**RFB # 25-0002**

**Addendum 1**

**CAMPBELL HALL 4<sup>th</sup> FLOOR  
CONSTRUCTION PHASE III**

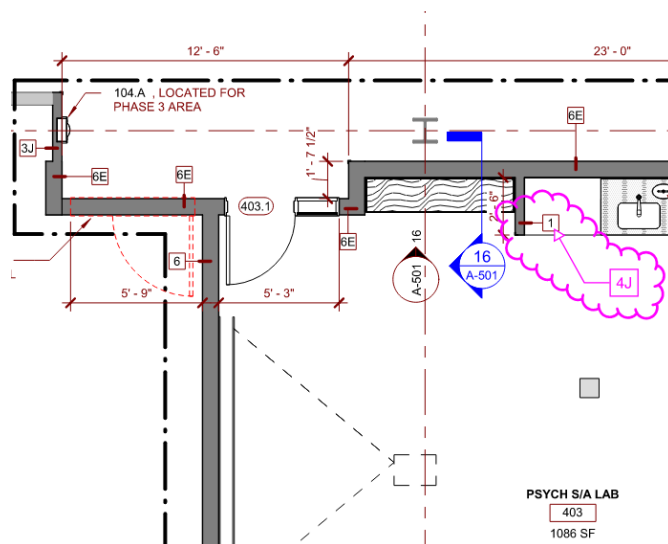
**3. Wall type 1 on A-601 is a furred wall 3 5/8 stud GWB one side. Assuming casework division wall (between casework and cubbies) is a 3 5/8 stud GWB ea side?**

Correct. See revision below on sheet A-401.

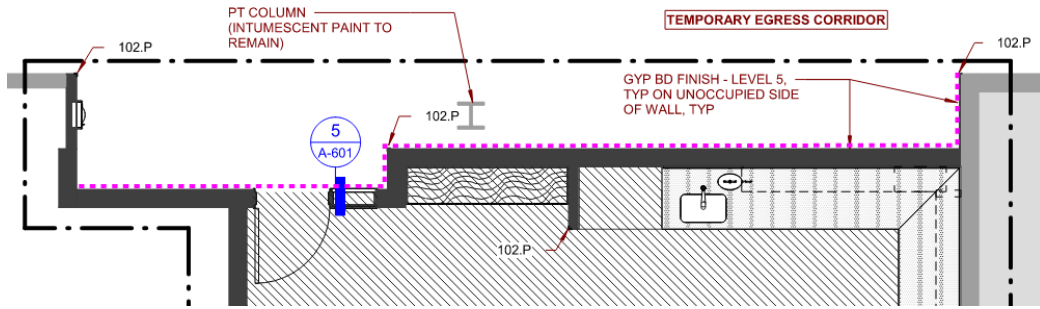
**a. Does this alcove area off temp corridor receive finishes – Paint, base, etc?**

Yes. See dash line below.
